SM300 ZTR Jumper TSB LAY-TSB-15-002

Date: March 12, 2015 **Model:** SM300

Product Issue:

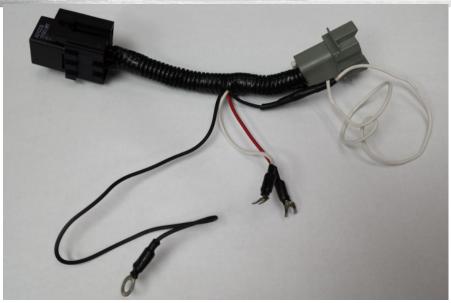
The primary goal of these rework instructions is to change the Relay power supply, pins 30 and 86, from battery power to ignition power.

- 1. Find ZTR jumper/relay under the right side of the dash panel.
 - a. You can follow the cable leading from the ZTR module, mounted to the right side of the dash support column, to the ZTR jumper.
- 2. Carefully note where the jumper connects into the SM300 electrical system.
 - a. At the end of this process the jumper will need to be re-installed in the same manner.
- 3. Disconnect the ZTR jumper, pictured below, from rest of unit's electrical system.
 - a. Cut the white wire in a way which is advantages for re-splicing during reconnection.

a.

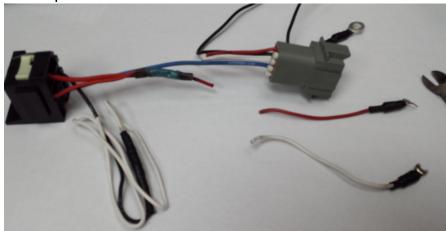
4. Remove loom and tape from jumper. Disconnect relay.

- 5. Cut the red and white wires leading from the grey connector as described and shown below.
 - a. Cut the red wire approximately 1 inch from the splice already present.
 - b. Cut the white wire at approximately the same location.
- 6. Cut the red wire with ring terminal coming from the already present splice flush to the splice.

- a.
- 7. Strip the following wires
 - a. Red and white wires with terminals.

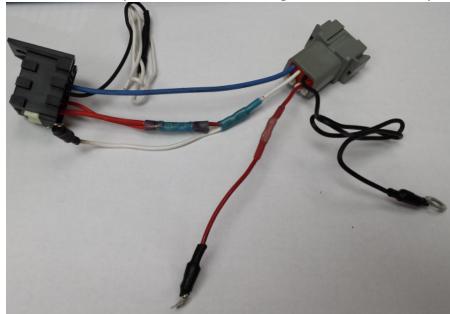
- b. Red and white wires extending from the grey connector.
- c. Red wire extending form the already present splice.
- 8. Splice the white wire (coming from the gray connector), the white wire (with the terminal), and the red wire (extending from the already present splice) together. Splice the red wire (coming from the gray connector) to the red wire (with the terminal).
 - a. Ensure that each wire is securely spliced and that the splice is environmentally sealed either through heat shrink or tape.
